REMARKS

Claims 1-17 are all the claims presently pending in the application. The specification and claims 1 and 3-4 are amended to more clearly define the invention and claims 5-17 are added. Claims 1, 3, and 9 are independent.

Claims 1-4 stand rejected under 35 U.S.C. § 103(a) as being unpatentable over the Message reference.

FIG. 6 PRIOR ART

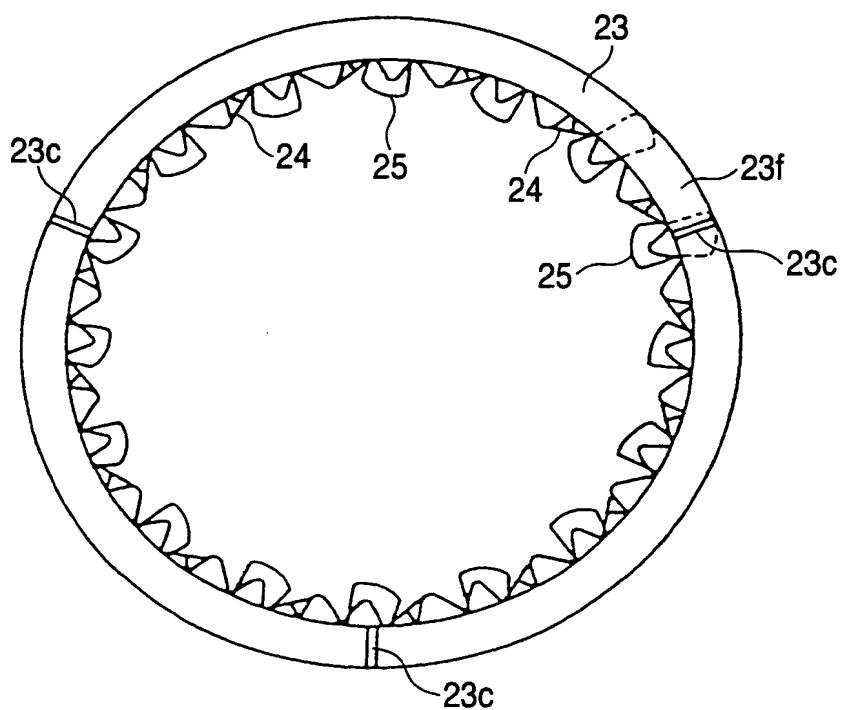
The Office Action objects to the drawings. This Amendment encloses replacement

The attached sheets of drawings include changes to Figs. 6-10. These sheets, which include Figs. 6-10, replaces the original sheets including Figs. 6-10. In Figures 6-10, a "Prior Art" legend has been added.
